ADDENDUM NO. 3

November 5, 2021

CROWN POINT HIGH SCHOOL ADDITIONS AND RENOVATIONS
Crown Point, IN 46307

This Addendum consists of Pages ADD 3-1 through ADD 3-2 and attached Addendum No. 3 from Gibraltar Design dated November 4, 2021 and consisting of 19 pages, Specification Section 08 34 73 - Sound Control Door Assemblies, Specification Section 11 66 43 - Scoreboards, and 107 drawings.

1 AD-110

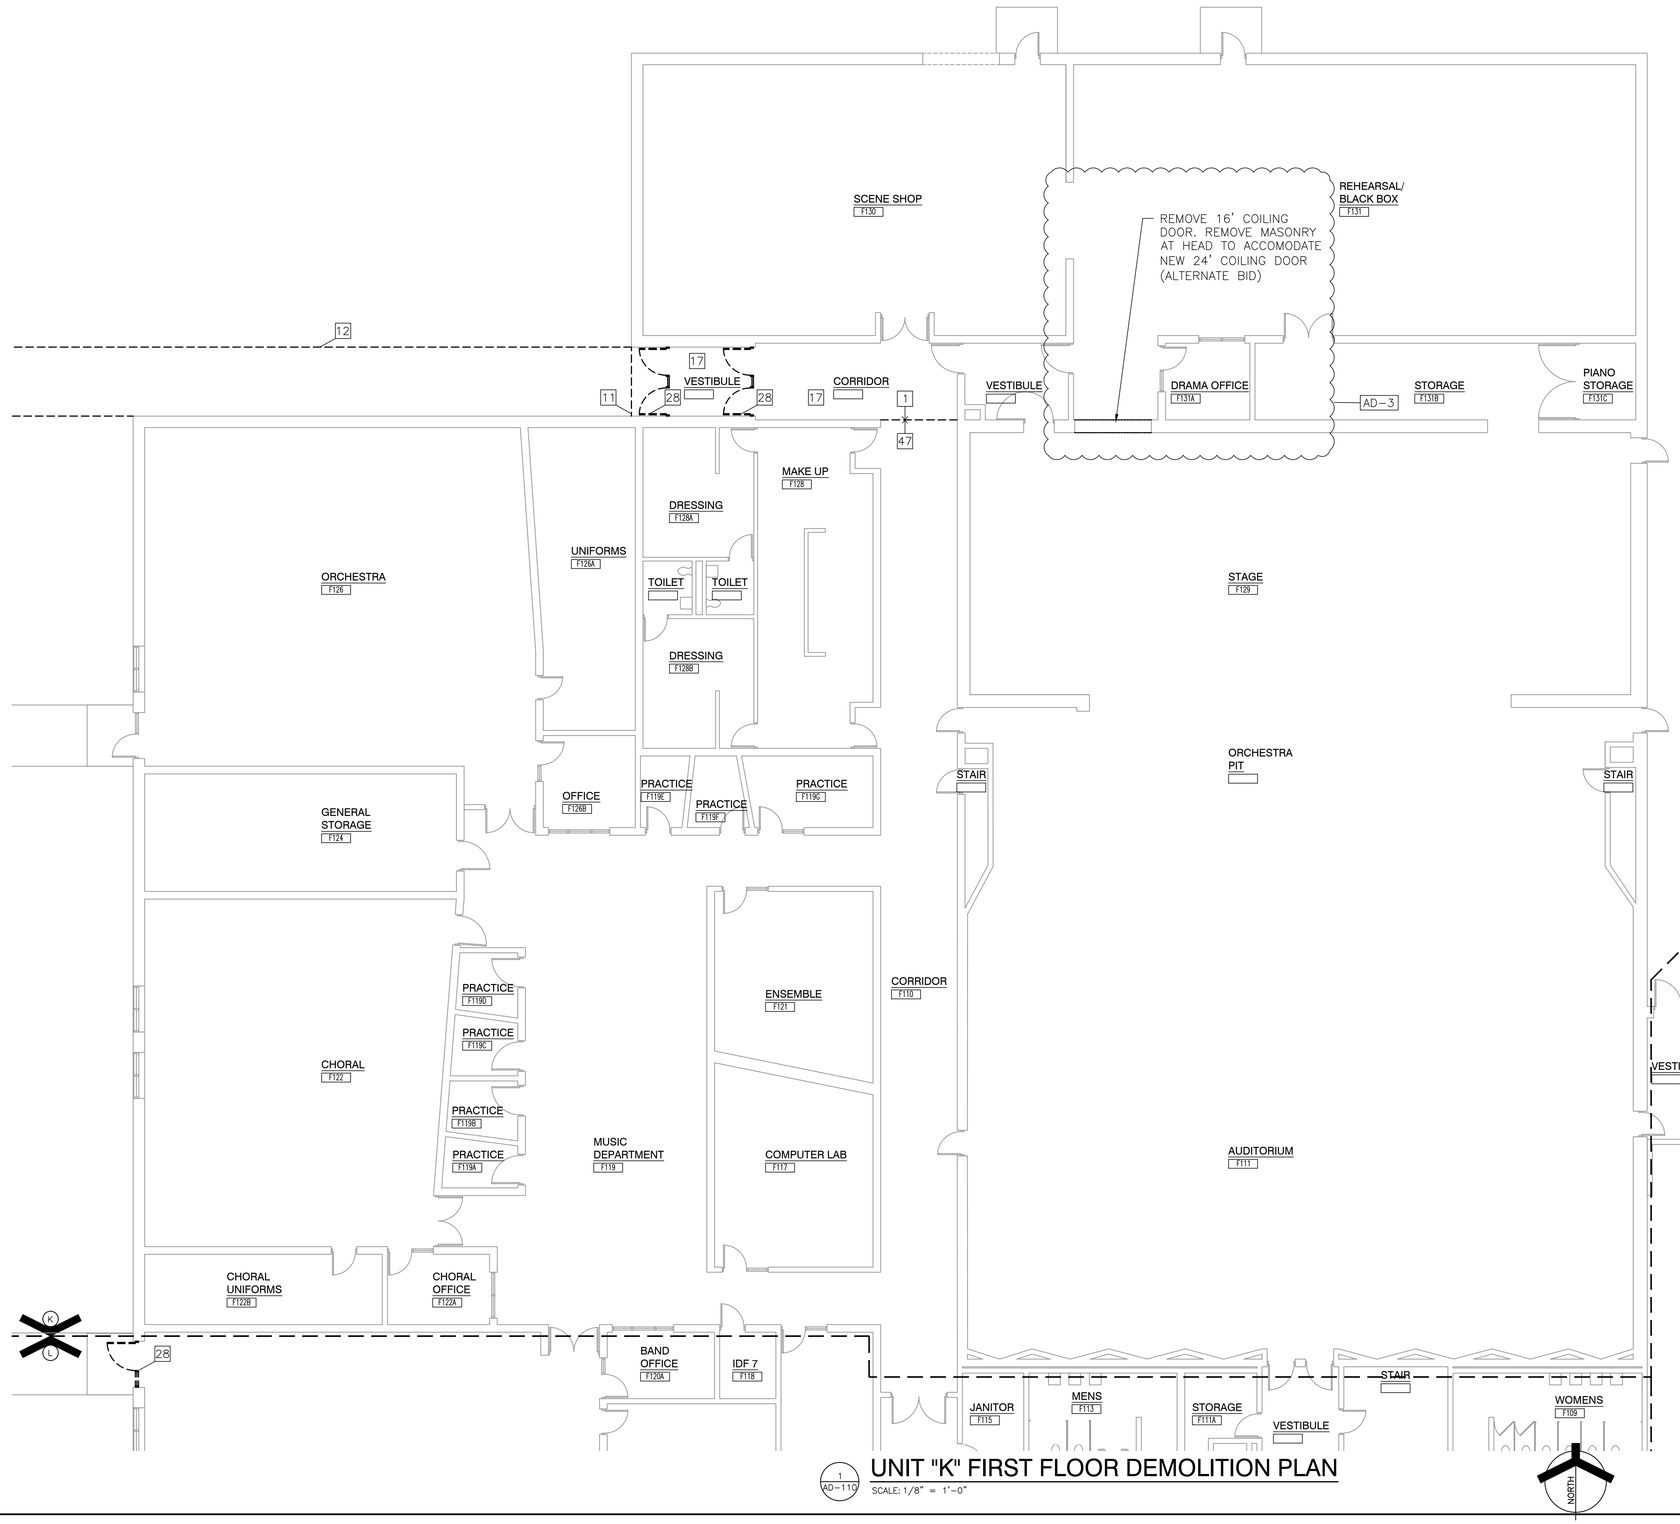
8. Sheet AD-110

1 / AD-112

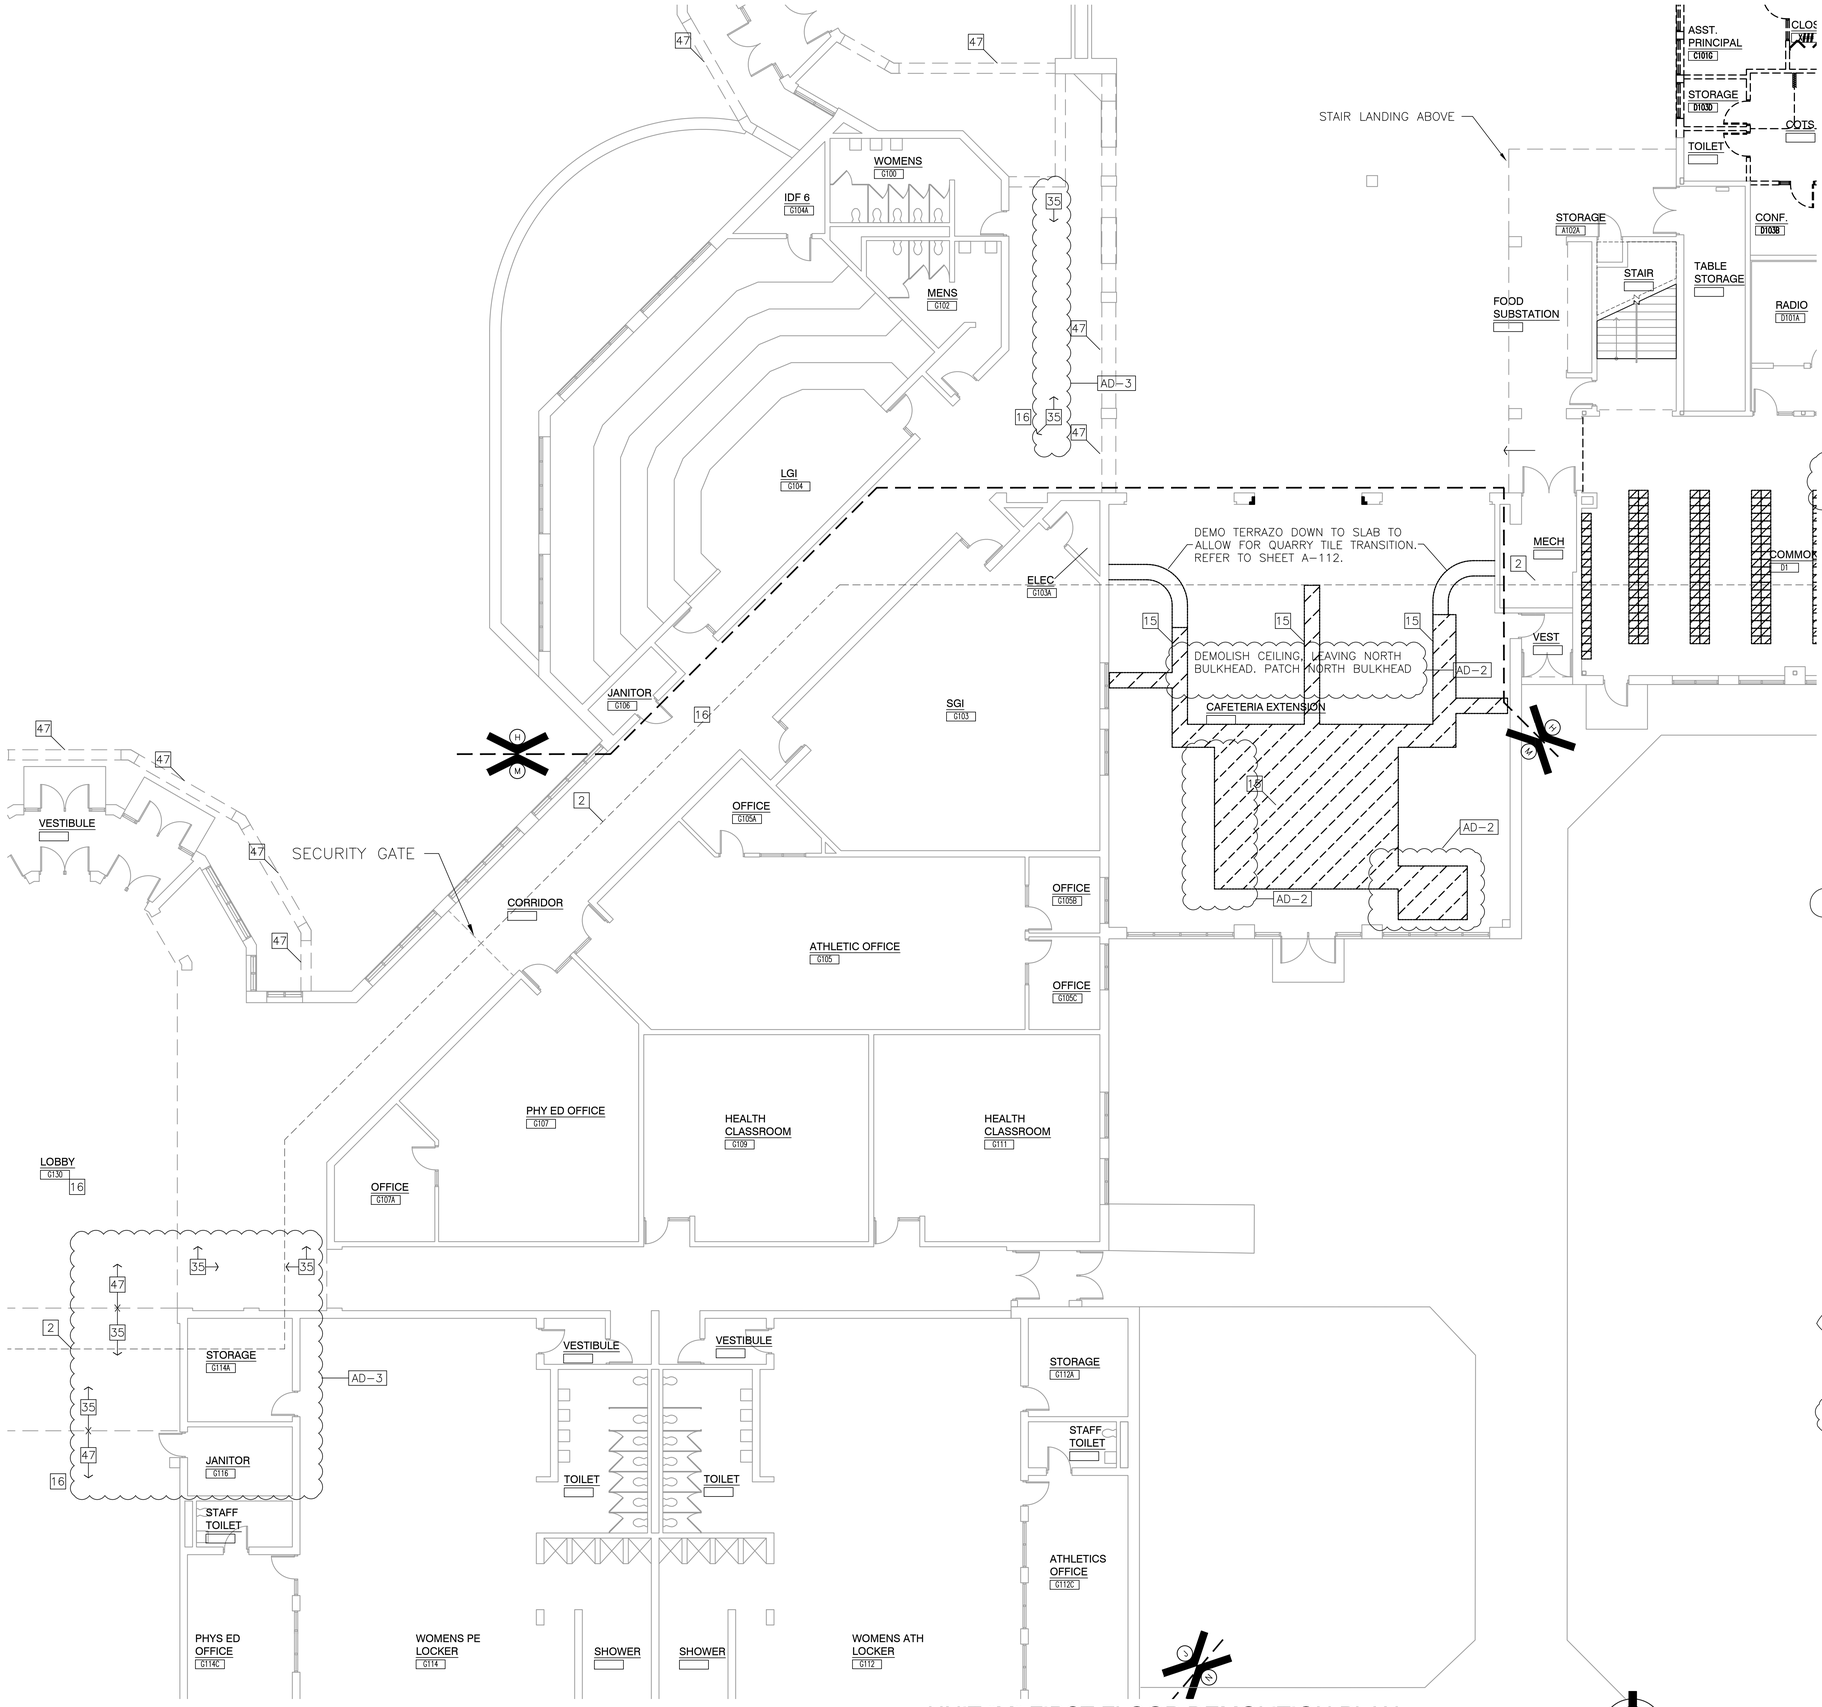
9. Sheet AD-112

1 AD-114

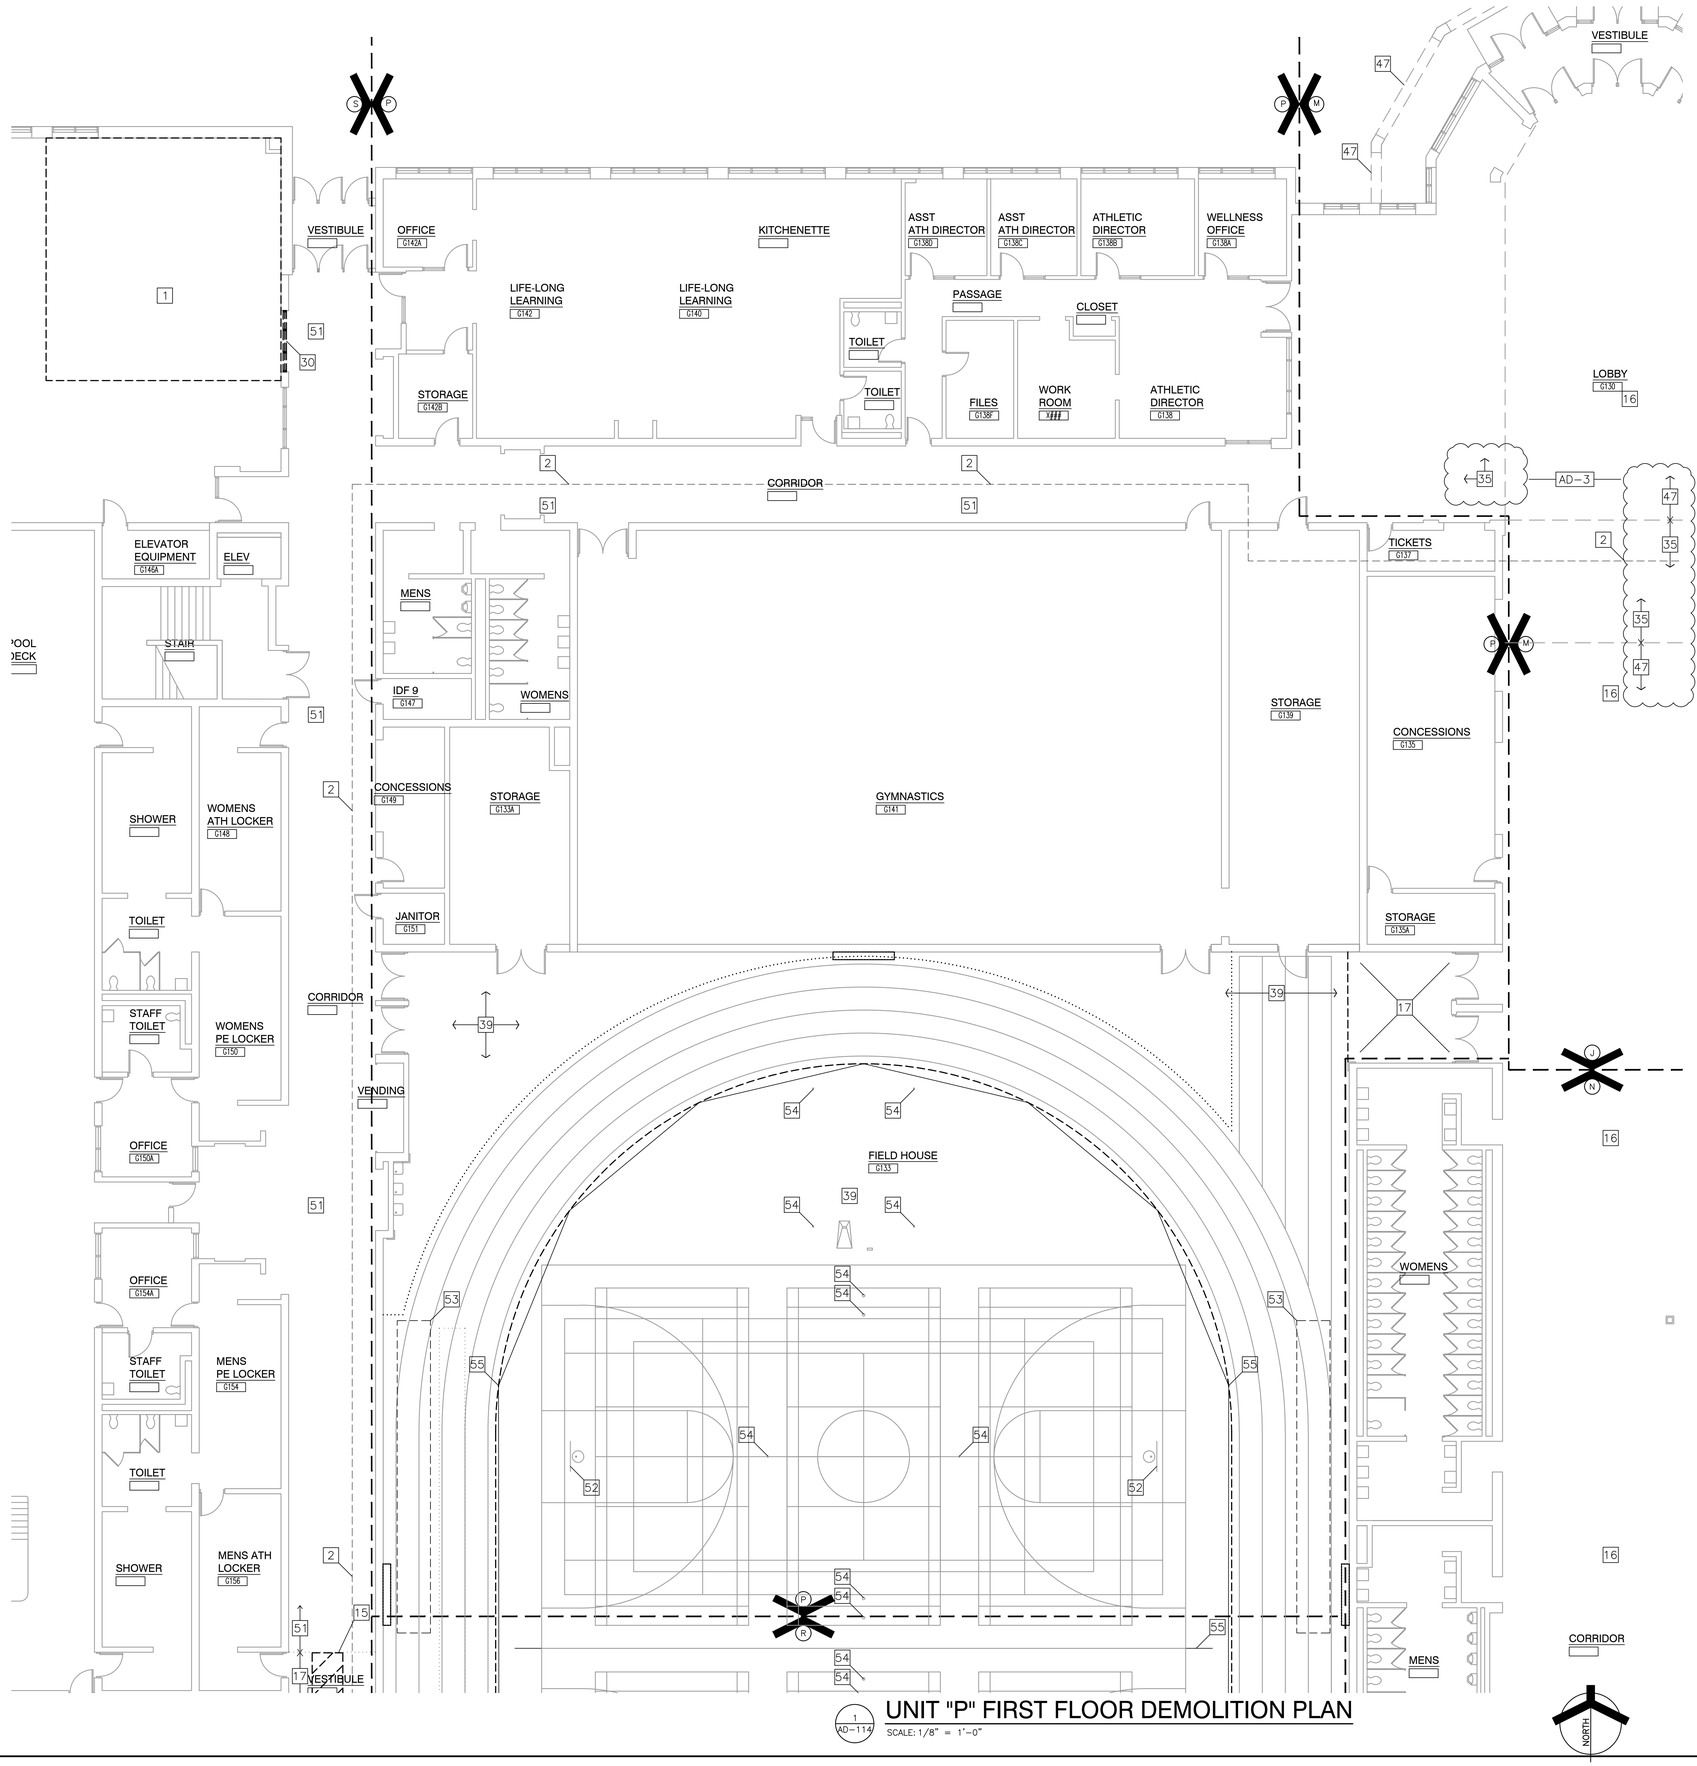
10. Sheet AD-114

1 AD-115

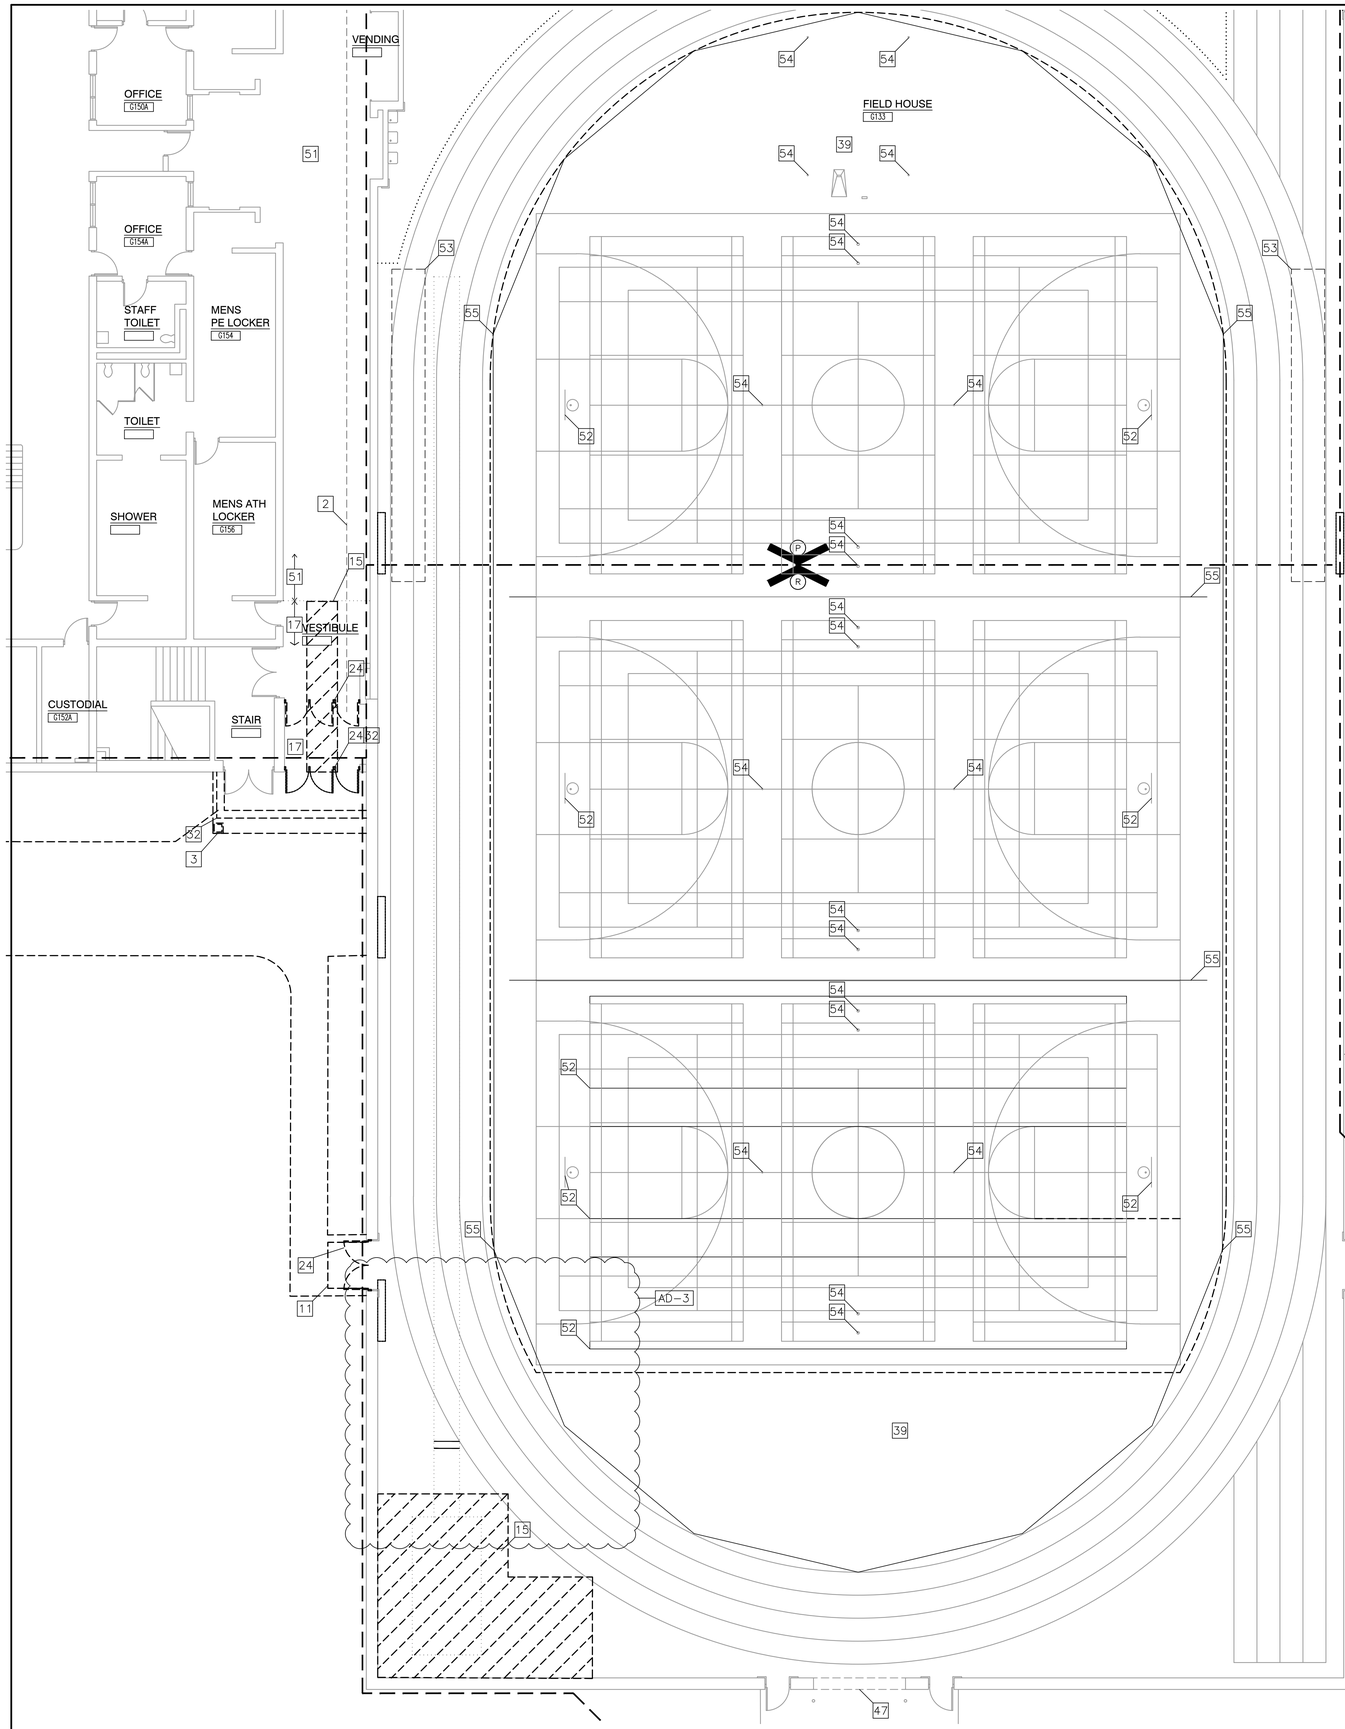
11. Sheet AD-115
